**Item 3.****Development Application: 278 Palmer Street, Darlinghurst**

File No.: D/2017/1332

**Summary**

Figure 14: Proposed ground floor plan

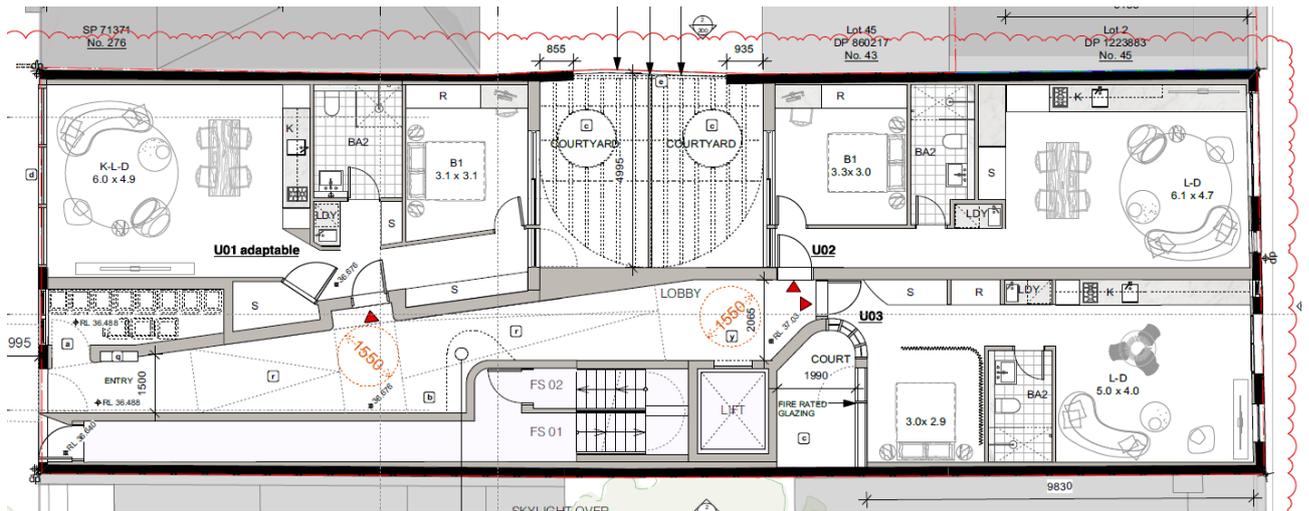
| 3E Deep Soil Zones  | Compliance | Comment   |
|---|------------|---|
| Deep soil zones are to have a minimum area equivalent to 7% of the site | No         | The proposal fails to provide adequate deep soil areas. The proposed deep soil areas at ground floor have existing joists as privacy/shading elements and therefore it is considered that only 2.7% deep soil area is provided to the site. |

83. Part 4.2.3.2 of the DCP requires lightwells to not be the only source of daylight to a habitable room.
84. All the proposed units rely on both northern and southern lightwells to provide a single source of daylight to bedrooms. The proposal therefore does not comply with this provision, and further, will potentially restrict future development on neighbouring sites.

85. Part 4.2.3.3 of the DCP requires common corridors to be at least 2m wide in front of the lifts. A lobby is provided for entrance to the units, with access from Palmer Street. The width to the lift from the lobby is between 0.8m and 1.55m. The proposal fails to comply with this provision. The lobby to the upper levels is partially unenclosed, which would likely result in safety and/or noise impacts, further, is not considered to provide acceptable outlook and the applicant has not demonstrated whether the lobby receives adequate solar access.

Figure 16: Proposed second level plan

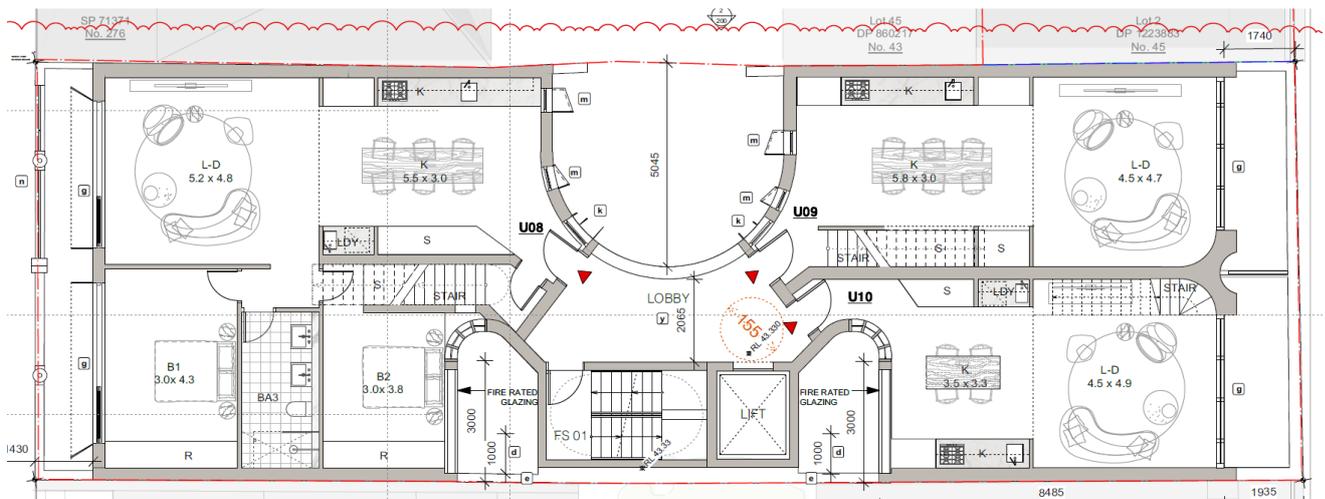
93. The applicant was requested on 24 April 2018 to provide a minimum setback of 1.67m without any protrusions such as awnings or external sun control devices to the top floor that faces Palmer Street (second level). The amended plans have a setback of 0.8m to a proposed awning from Palmer Street.

94. It is also required that a suitable setback from Sherbrooke Street of 2m minimum is provided to maintain the streetscape presentation and mitigate visual impacts. The amended plans propose a setback from Sherbrooke Street of 1.495m.

Figure 20: Proposed south elevation

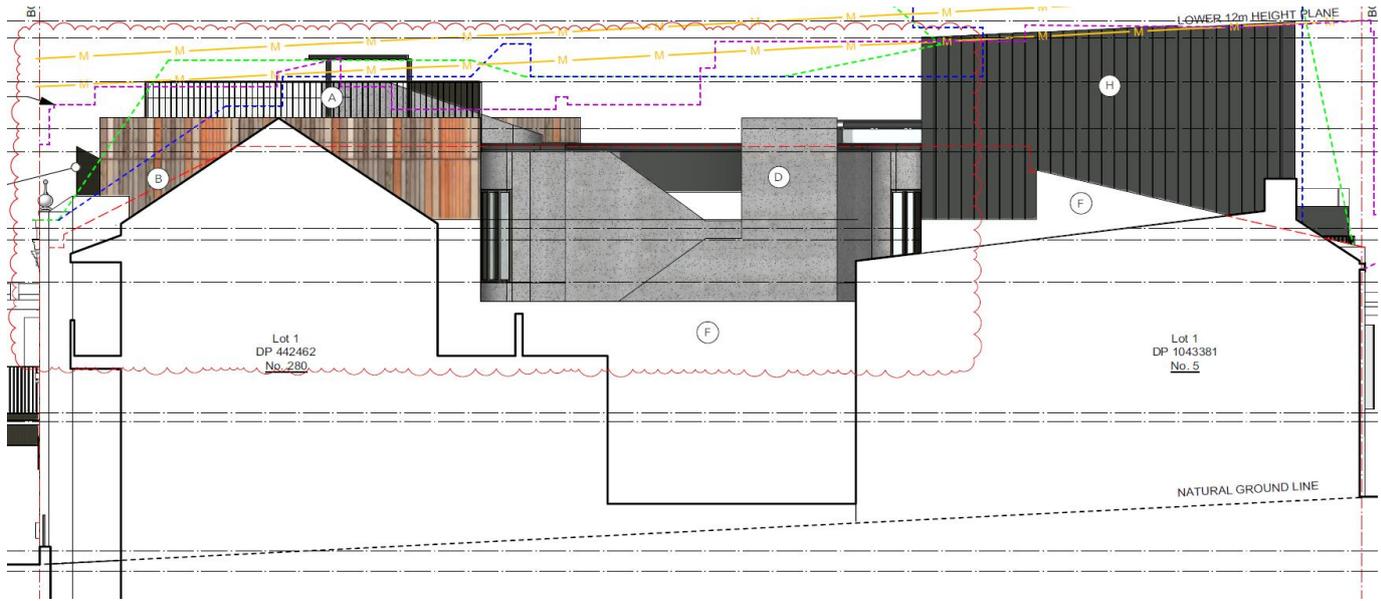
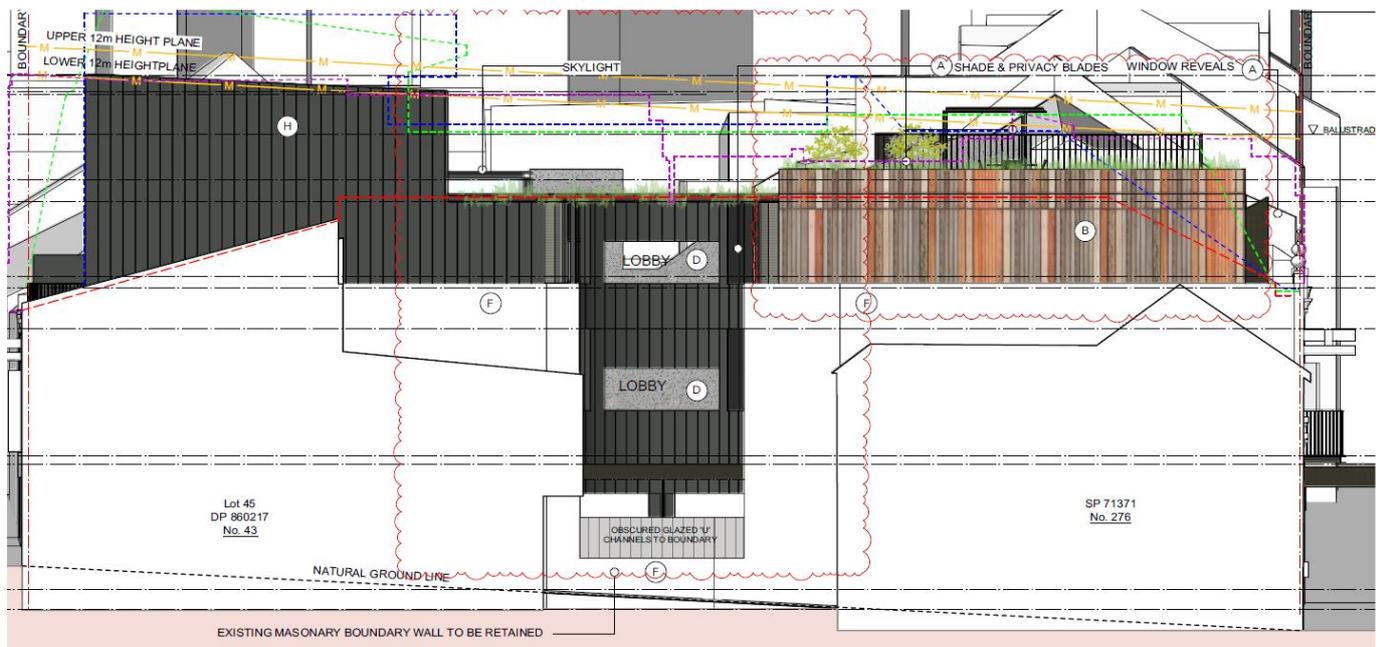
- (c) *Inaccuracies in the development application 'Elevations' plan - Dominion Building is to the west, and is 7 storeys*

**Response** - Noted, however as discussed above the proposal is not recommended for approval. The inaccuracies are not considered significant to require amendments for the purposes of the assessment.

**Figure 24:** Zoning of site in context of LEP 2012 controls for land use

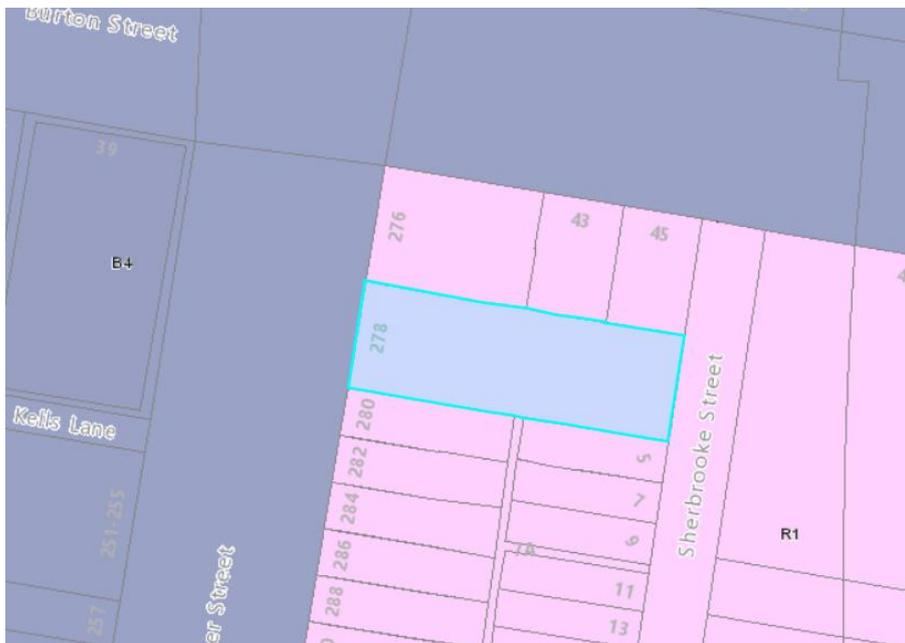
46. Part 4.2.1 of the DCP requires the height in storeys of developments to reinforce the existing or future neighbourhood character. Further, Clause 4.2.1.1(1) specifies 'development must not exceed the maximum number of storeys as shown in the building height in storeys map and (5) Height of buildings and street frontage height in storeys should not match anomalous tall neighbouring buildings that are inconsistent with the neighbourhood.'

47. To the north of the site, 276 Palmer Street, and 43 and 45 Burton Street, are permitted a three storey maximum height control. North of Burton Street, an eight storey control is applied to the 'Republic II' building. It is noted that this area is within the 'B4 Mixed Use' zone whilst the subject site is within an 'R1 General Residential' zone (see Figure 23).

48. Whilst the proposal generally maintains a 12m height limit, a four storey built form is proposed to the Sherbrooke Street frontage, with both storeys of the addition setback by 1.495m from the existing building frontage. To the south of the site most of the built form comprises predominately uniform two storey terraces. The fourth storey appears overbearing on the heritage street scape and Heritage Conservation Area.
49. Part 4.2.2.2 of the DCP requires a setback above the street frontage height to be a minimum of 3m for residential above residential. This is not proposed. A setback to Sherbrooke St of 1.495m for both third and fourth storey additions is proposed which is considered to insufficiently address the street scape requirements and cause visual impact (and privacy issues) to surrounding neighbouring properties.

Figure 26: Extract from stamped plans - D/2009/1123 - showing area to be redesigned to minimise overshadowing

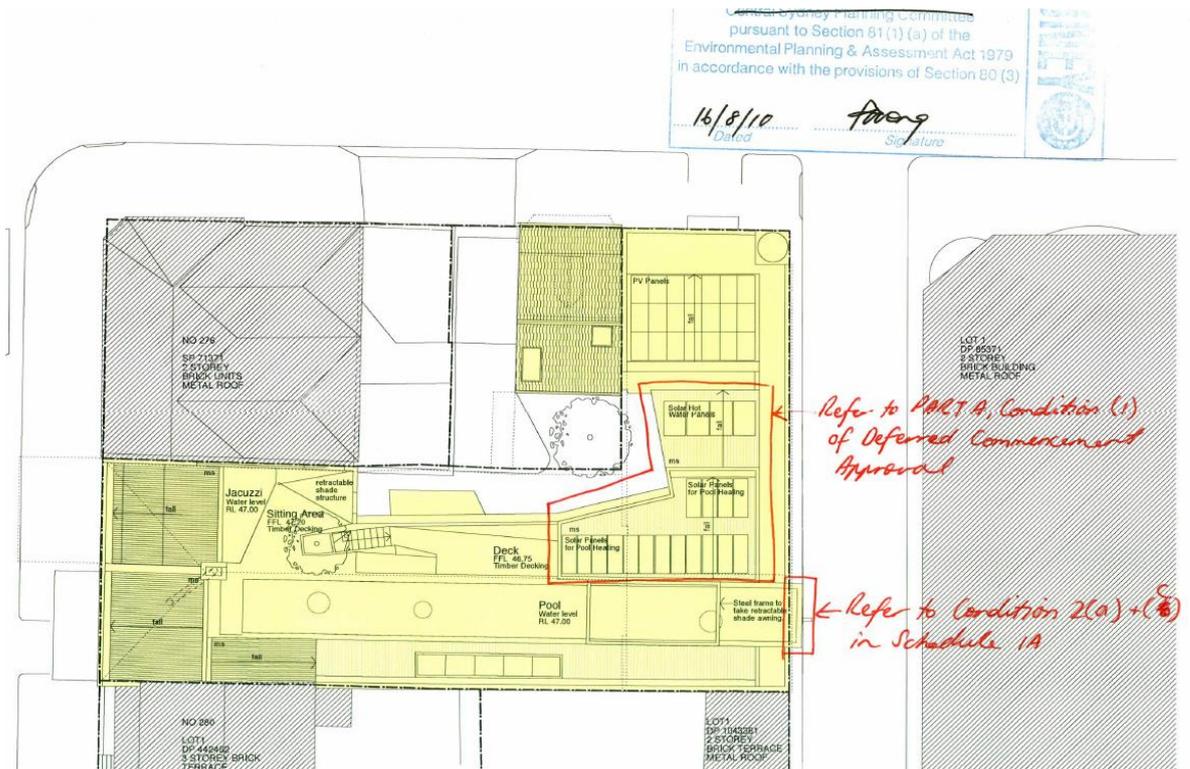
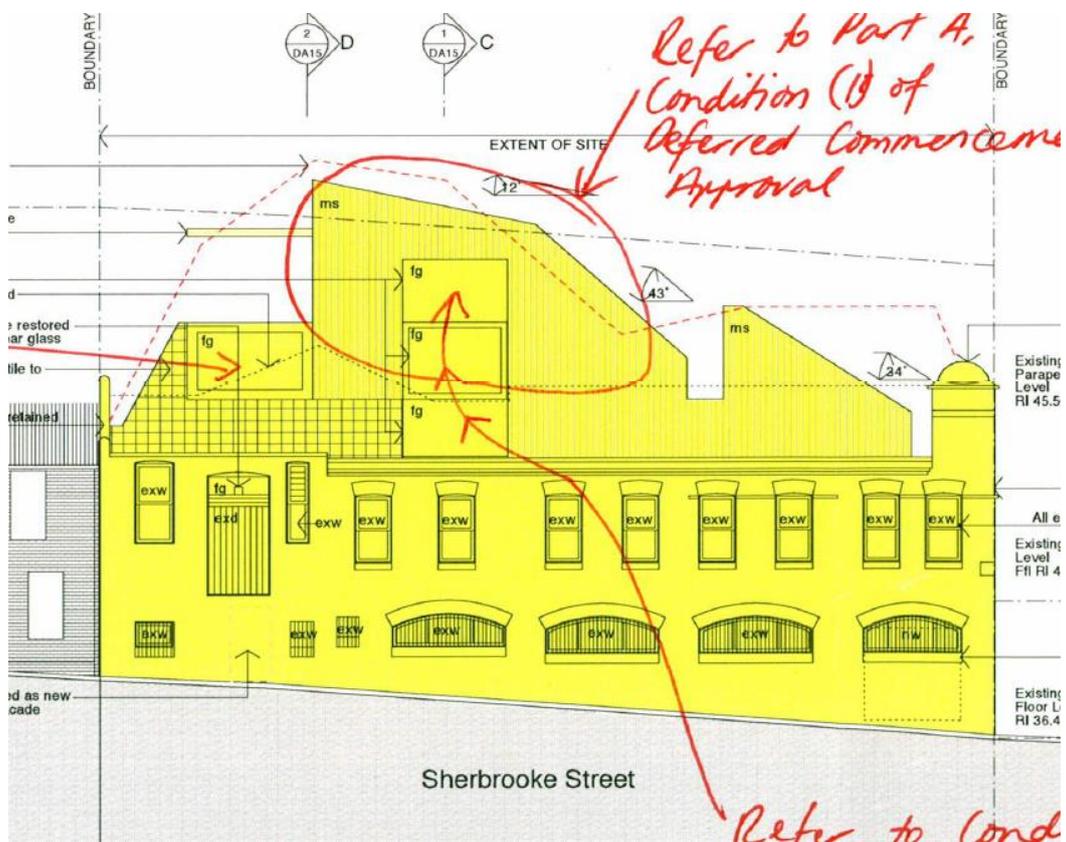
66. A previous application for the site (reference D/2009/1123) was issued deferred commencement approval at the site on 16 August 2010 by Council for alterations, additions, and conversion into a three storey residential dwelling including excavation for a basement level containing car parking, retention and conservation of the facade of the terrace, an additional floor to the existing warehouse building and an upper level deck with lap pool. The approval lapsed on 16 August 2015 and was not commenced.

67. The approval included conditions to be satisfied prior to consent operating including a re-design of the lift, stair and cabana structure, to be amended to ensure the proposal does not result in any additional overshadowing to the rear private open spaces of adjoining properties, particularly properties that currently receive less than two hours of sunlight to a minimum 50% of private open space between 9.00am and 3.00pm at the winter solstice (21 June) as outlined in Figure 26 and 27 below.

68. Council records show that the imposition of the deferred commencement condition is a result of concerns in relation to the loss of solar access, indicating that impacts to the properties experiencing less than two hours of sunshine in midwinter could be reduced if the access to level 3 and the 'cabana design' with solar panels above was redesigned. Studies were undertaken using computer analysis during the assessment and it was determined that the lift and its roof (the eastern end of the structure) is more responsible for the minor shadow impact rather than the western end of the cabana.

**Response** - The previous DA at the site D/2009/1123 does not have relevance to this assessment, except that it is noted that a condition of the deferred commencement approval related to a redesign to minimise overshadowing. This condition is not considered appropriate to this development application. As such the proposal is recommended for refusal.
